BROWNS FERRY NUCLEAR PLANT, UNIT NO. 1

AMENDMENT TO FACILITY OPERATING LICENSE

Amendment No. 76  
License No. DPR-33

ATTACHMENT TO LICENSE AMENDMENT NO. 76

Figure 3.5.K-1  
MCPR LIMITS\*

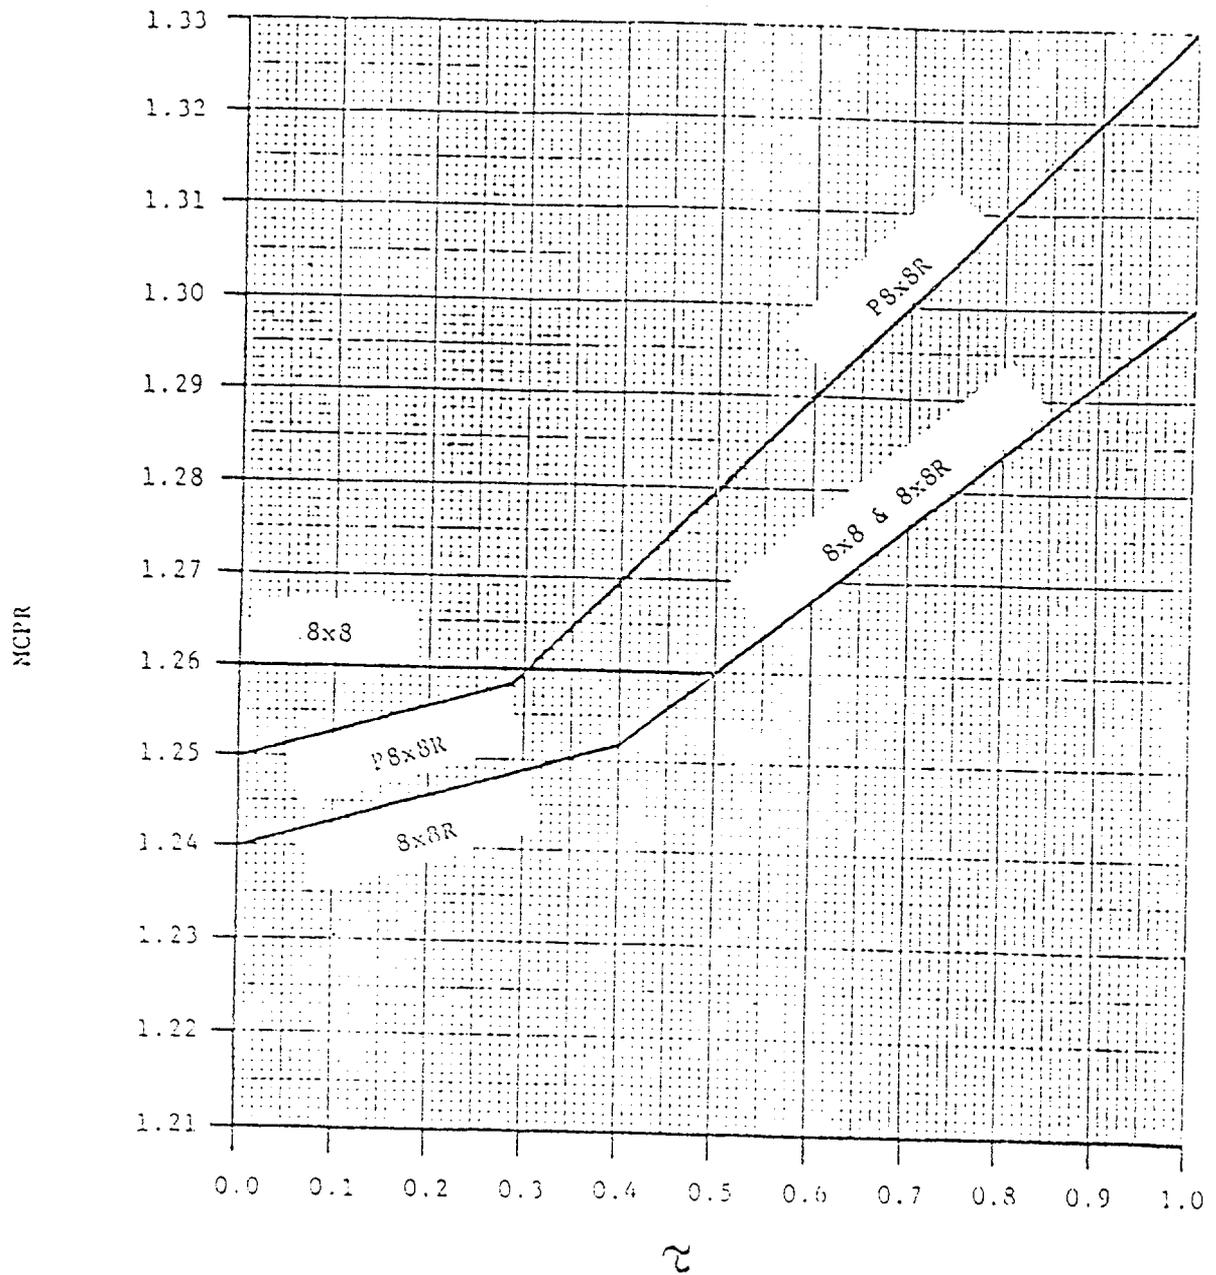
Pgs 160 and 172b - As supported by the reload submittal, the operating limit MCPR's are being changed. Since the MCPR's were determined by the OLYN Code (rather than the REDY Code), OLMCPR's are now calculated from two curves rather than being a single value (or a ramp change with fuel exposure).

The minimum critical power ratio (MCPR) as a function of scram time and core flow, shall be equal to or greater than shown in Figure 3.5.K-1 multiplied by the  $K_f$  shown in Figure 3.5.2, where:
